# **GRACE CATHEDRAL CLOSE ALTERATIONS Final Environmental Impact Report**

**91.121E**

Final EIR Certification Date: February 11, 1993

**Figure 3**  
Ground Level Floor Plan

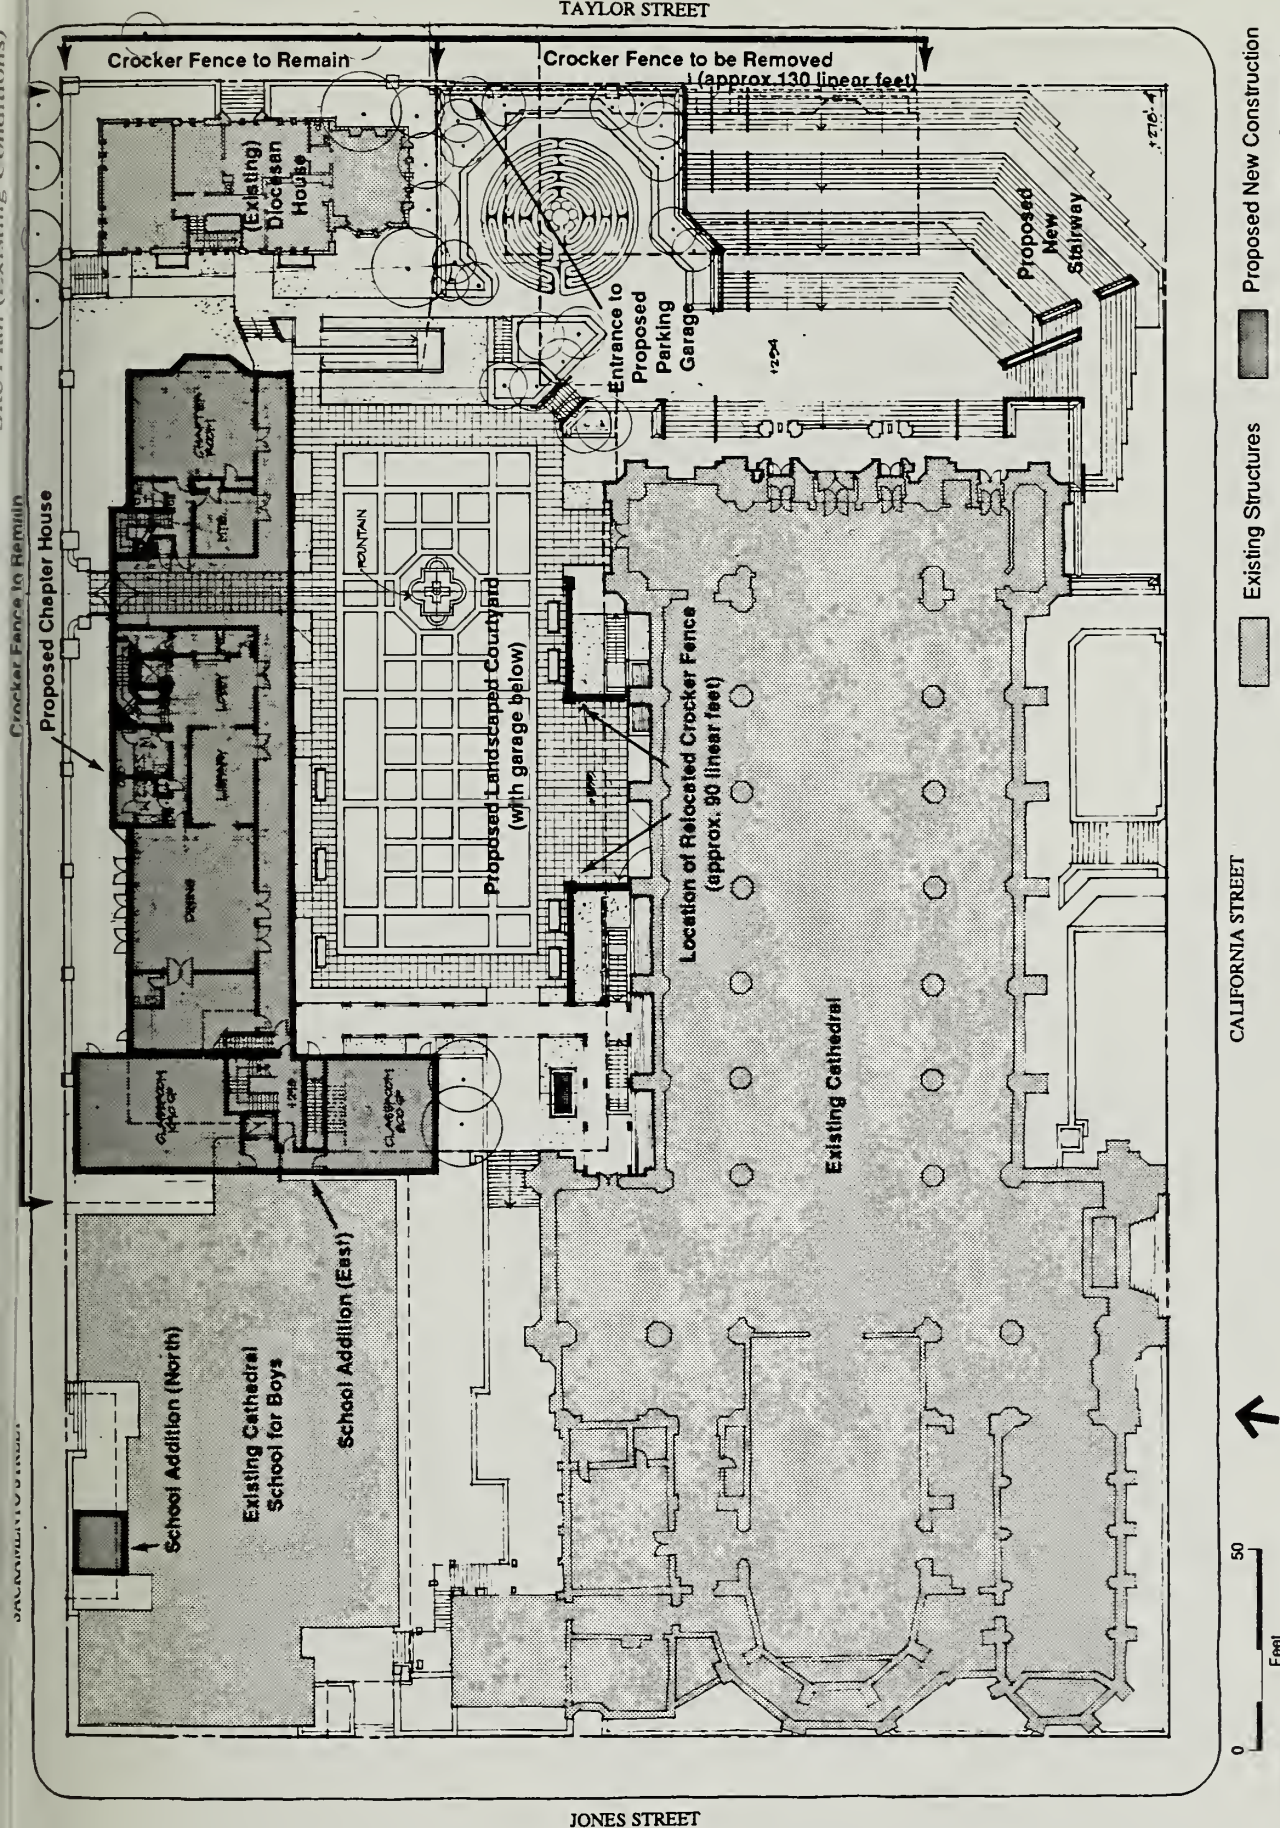
Both the Ground Level Floor Plan and First Basement Level Floor Plan (Figures 3 and 5, pages 18 and 20) show that the Chapter House would be set back approximately 25 feet from the Sacramento Street property line (but that the School additions would abut the northern site boundary).

The Ground Level Floor Plan (Figure 3, page 18) clearly shows a door connecting the Chapter House and School. Does the San Francisco Fire Department (or Uniform Fire Code) permit such connections between two buildings?

**Figure 6**  
Taylor Street Elevation

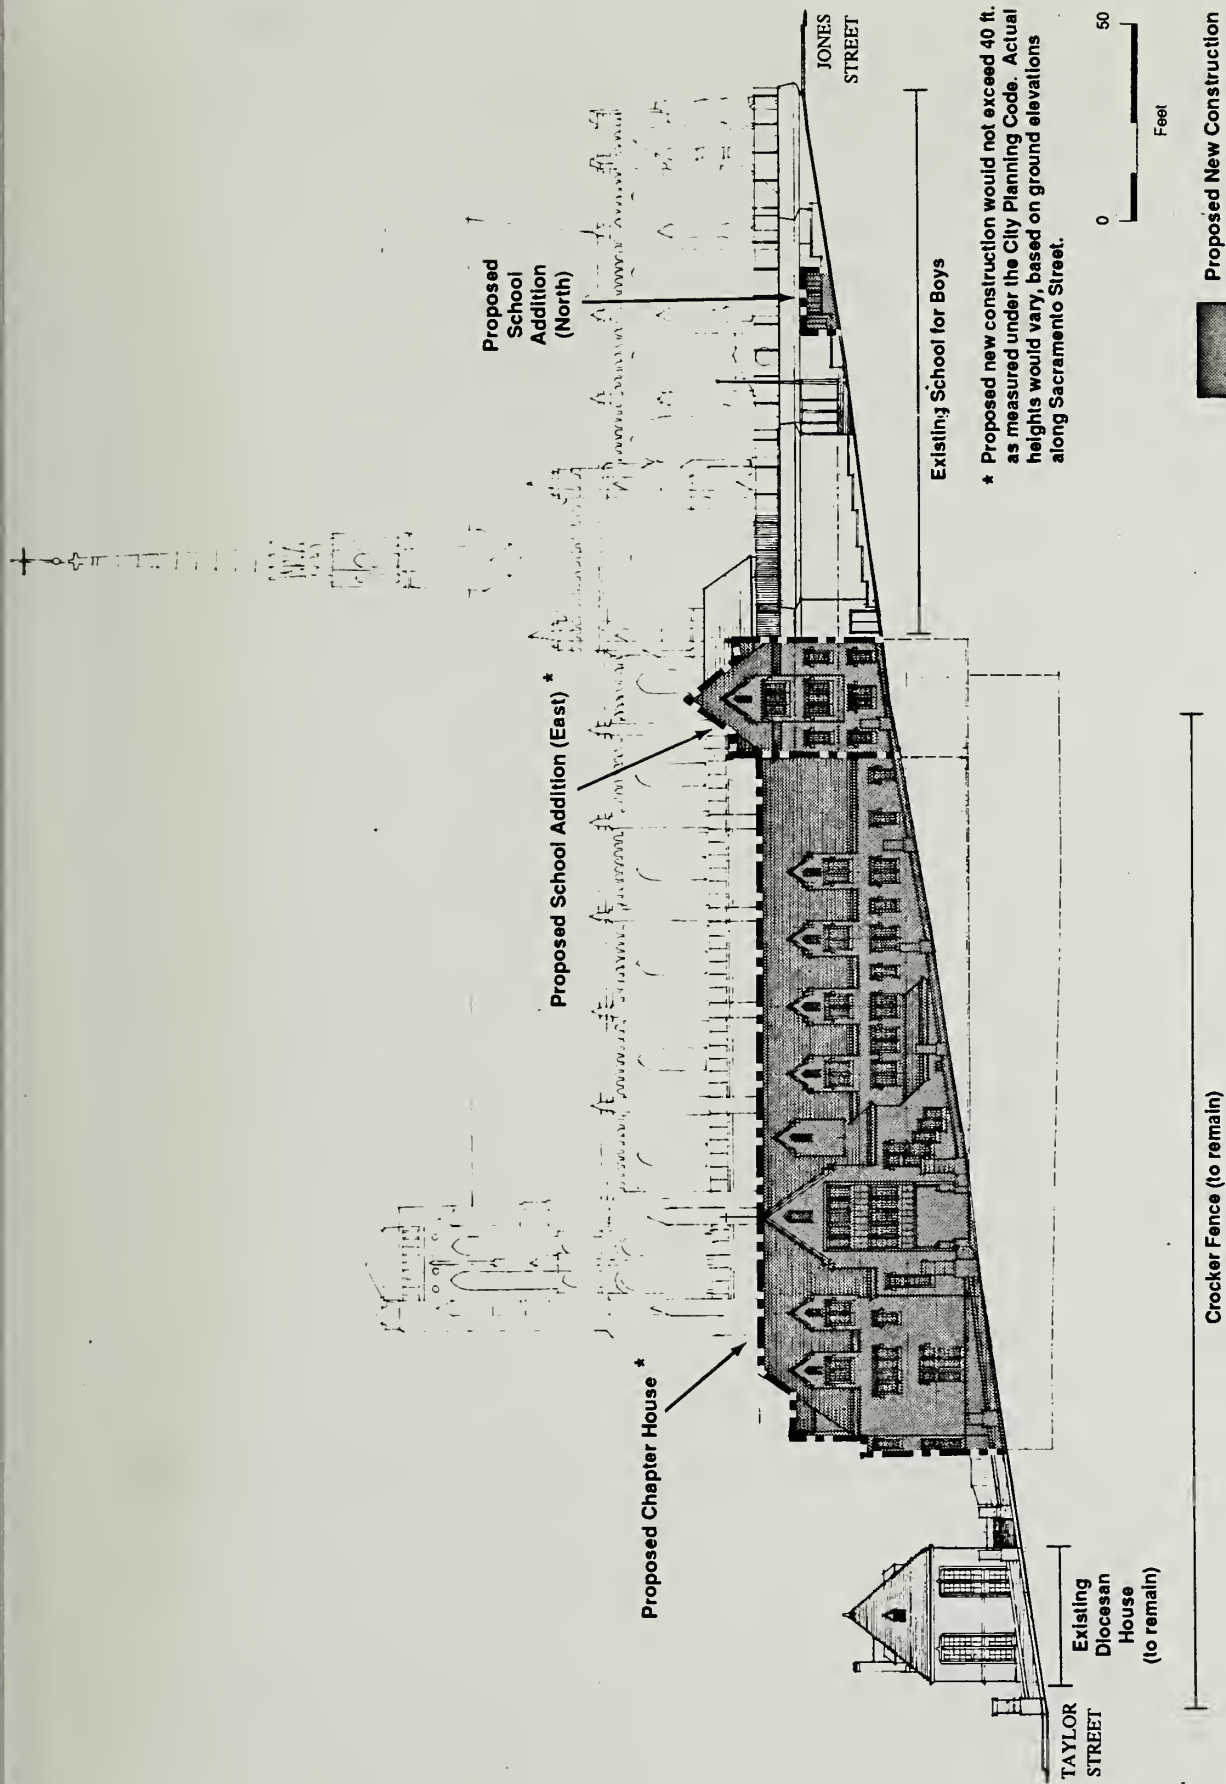
In Part II of the Draft EIR, "Project Description", the only illustrations of the proposed project (other than floor plans) are Figures 6 and 7, on pages 21 and 22. These drawings do not show sufficient detail, especially in the case of the proposed new Staircase and Parking Garage Entrance shown in Figure 6. It would be much more helpful to include a photomontage (or, at

least, a more detailed drawing) to show the actual appearance of these new structures and exactly where cars are intended to enter and exit the new garage. The aesthetic impact of the garage entrance, and the necessity for removing all of the Crocker Fence along the 130 foot long section proposed for removal, are not clearly demonstrated in the simplified drawing in Figure 6. (The garage entrance could potentially have a very negative impact on the sidewalk-level view of the Cathedral Complex along Taylor Street.) (Michael Levin)

**Figure 5(Revised)**  
First Basement Level  
Floor Plan

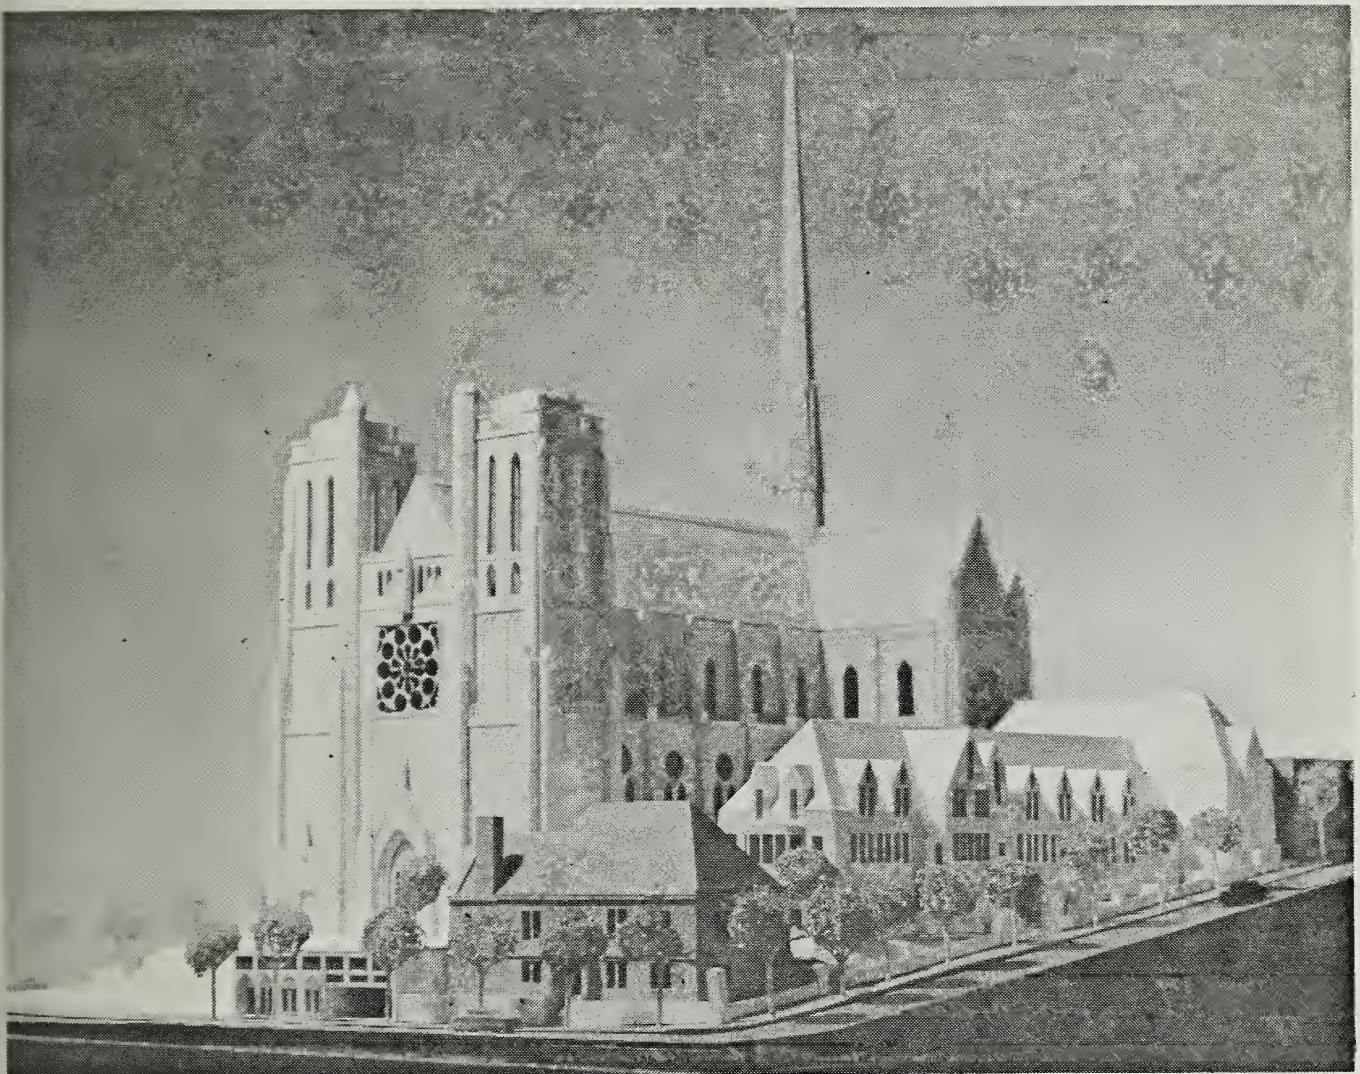
Please provide a plan for the second basement level (in order to clarify garage circulation, specifically the proposed Taylor Street driveway which is shown nowhere in the EIR). (Stanley Herzstein and Enid Lim, Nob Hill Neighbors)

Figure 5, on p. 20 of the Draft EIR, is revised as shown below to indicate the location of the driveway to the proposed subsurface parking garage, immediately south of the existing Diocesan House. Inbound traffic would use the lane on the north side of the driveway; outbound traffic would use the lane to the south. The second basement level floor plan was not included in the Draft EIR because of its similarity to the first basement level floor plan, and because parking plans are reviewed by Department of City
